SUNDRY NOTICES AND REPORTS ON WELLS

J. L. KEEL "B" #65

# DEVON ENERGY CORPORATION WELLBORE SCHEMATIC

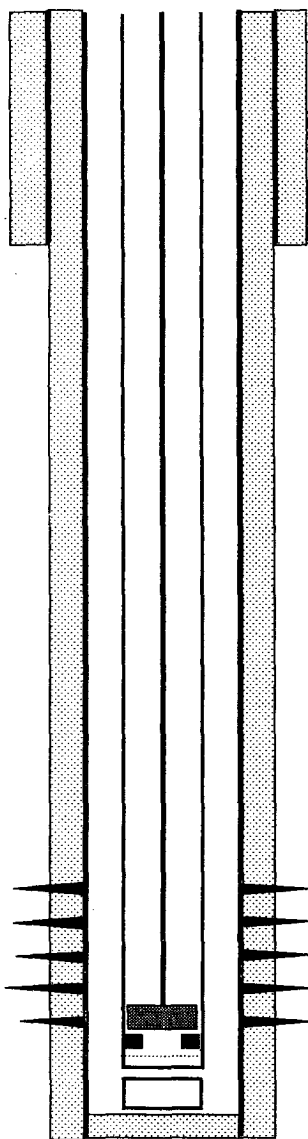
1. Approval is granted to P/A this well with the following modifications to the procedure:
2. The plug proposed for 1525' should be moved to 1255' for the base of the salt.
3. The plug proposed for 485' should be moved to 623' for the top of the salt and the 8.625" casing shoe.
4. The plug proposed for 63' should be moved to 100' or the tag depth of the plug @ 552', which ever is more shallow.

**\* All plugs, including the surface plug, should leave at least 25 sacks of cement inside the casing and be at least 100 feet, plus an additional 10% for each 1000 feet of depth.**
